Office Action Summary

10/665,395

DETAILED ACTION

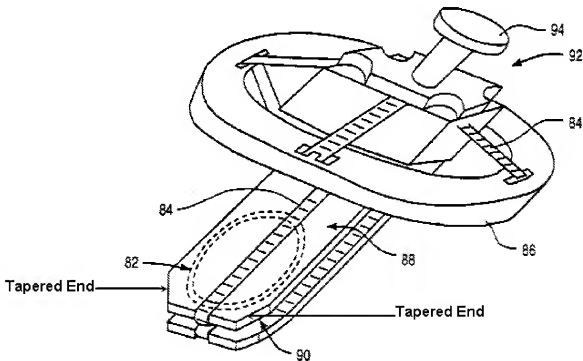
Regarding claim 58, Mueller et al. clearly disclose the distal end of obturator 88 to have a taper (see marked up Fig. 10B provided below) when the retractor is received in the groove or longitudinal channel 89 of the insertion tool. Shaft 95 of the insertion tool engages the retractor when it is used to push the retractor out.
